Contract #: 04-0120F4Cty: SF/ALA Rte: 80 PM: 13.2/13.9File #: 69.28**WELDING INSPECTION REPORT****Resident Engineer:**Siegenthaler, Peter**Address:** 333 Burma Road**City:** Oakland, CA 94607**Report No:** WIR-024902**Date Inspected:** 29-Jun-2011**Project Name:** SAS Superstructure**OSM Arrival Time:** 700**Prime Contractor:** American Bridge/Fluor Enterprises, a JV**OSM Departure Time:** 1900**Contractor:** Zhenhua Port Machinery Company, Ltd (ZPMC), Changxing Island **Location:** Shanghai, China**CWI Name:** An Qing Xiang**CWI Present:** Yes No**Inspected CWI report:** Yes No N/A**Rod Oven in Use:** Yes No N/A**Electrode to specification:** Yes No N/A**Weld Procedures Followed:** Yes No N/A**Qualified Welders:** Yes No N/A**Verified Joint Fit-up:** Yes No N/A**Approved Drawings:** Yes No N/A**Approved WPS:** Yes No N/A**Delayed / Cancelled:** Yes No N/A**Bridge No:** 34-0006**Component:** OBG**Summary of Items Observed:**

BLAST SHOP 1, OBG 14E

BLAST SHOP 2, OBG 14W

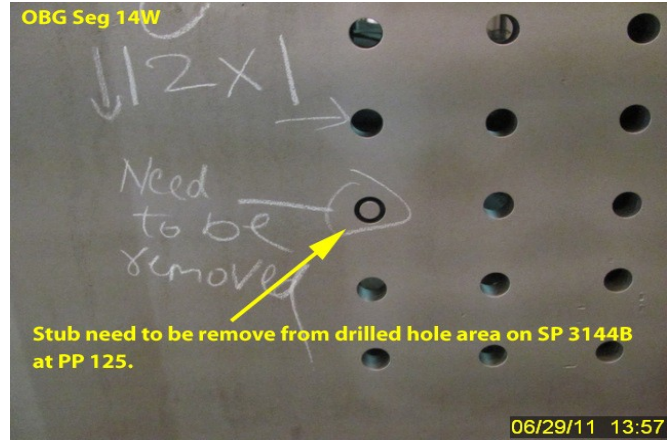
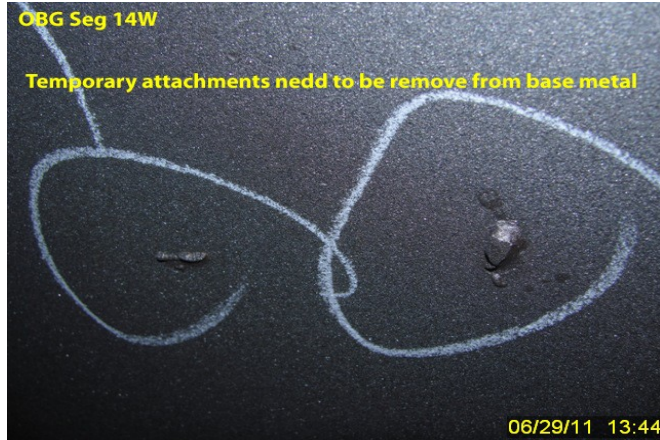
This QA Inspector performed Blast inspection on base metal, fillet welds and complete joint penetration (CJP) welds from panel point (PP) 125 to PP128.7 on external surface of vertical plate, side panel, edge panel and bottom panel of OBG segment 14East on at cable side. During inspection, several non conforming discontinuities such as weld spatter, deep gouges and arc strikes were observed. At PP 125 the stub was not removed from drilled hole area was observed. These areas were marked up for repair. All information regarding this marked on weld

map and submitted to Lead QA Inspector. See attached photos for additional information.
